Designated Parking Corp. CONFIDENTIAL		
Title: HT390 Hand Held Transmitter,		
Size	Assembly Number: 02-6023	REV
Tabloid	Date of Revision: April 5, 2004	B4
	Document Number: 02-6023 B4.SCH	
Sheet 1 of 1		Printed on: 6-Apr-2004

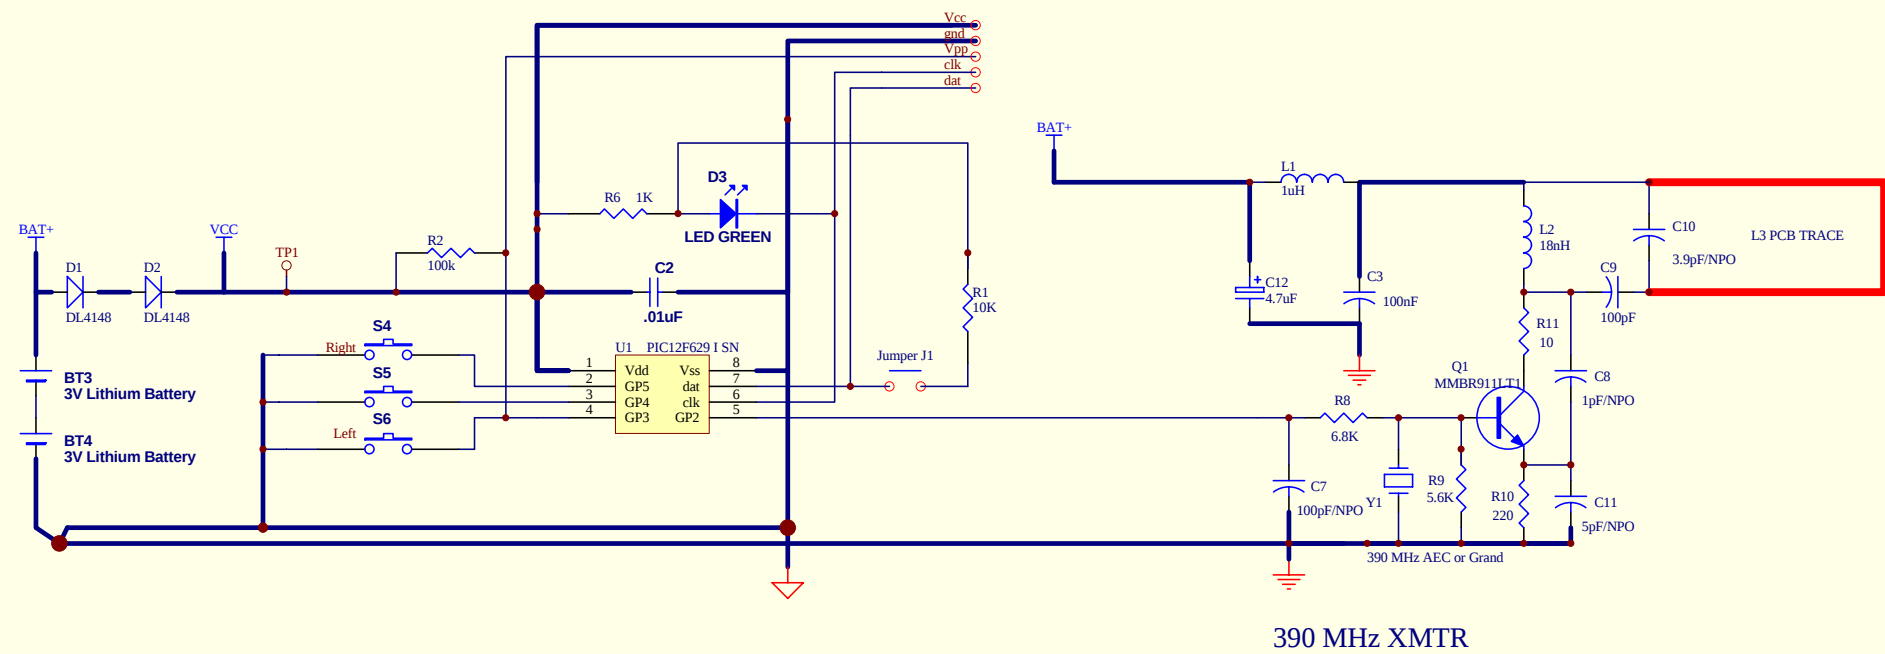
1-9-2004 ECO1005: Changed ICP Pin Vpp now connected to GP3
 ECO 1022B 3-16-04 R11 was 10 ohm
 Rev B4: ECO 1025 4-5-04 change caps per list and chnage R11
